U.S. Department of the Interior BUREAU OF LAND MANAGEMENT		Sundry Print Report 05/20/2024
Well Name: POKER LAKE UNIT	Well Location: T24S / R30E / SEC 19 / SENW /	County or Parish/State: EDDY / NM
Well Number: 279	Type of Well: OIL WELL	Allottee or Tribe Name:
Lease Number: NMNM02860	Unit or CA Name: POKER LAKE DELAWARE C	Unit or CA Number: NMNM71016G
US Well Number: 3001535477	Operator: XTO PERMIAN OPERATING LLC

Notice of Intent

PLUG AND ABANDON WELLBORE POKER LAKE UNIT 279 EDDY COUNTY, NEW MEXICO Class II

PLU 279 - Proposed WBD

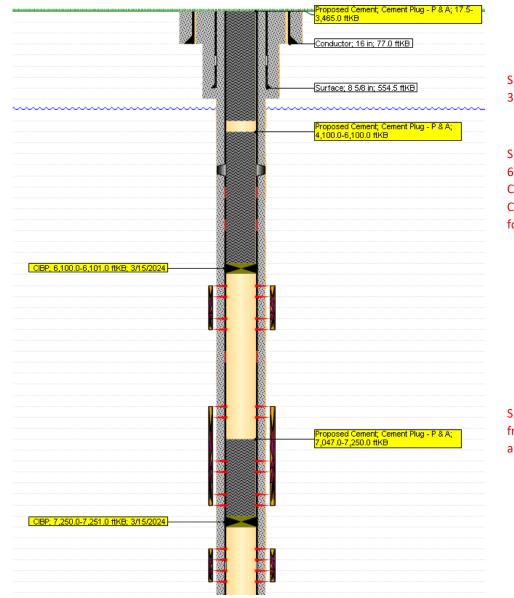
Created By	Condition	Condition Date
gcordero	Run CBL from 6100' to surface. CBL must be submitted to OCD via OCD permitting before submitting C-103P	5/24/2024
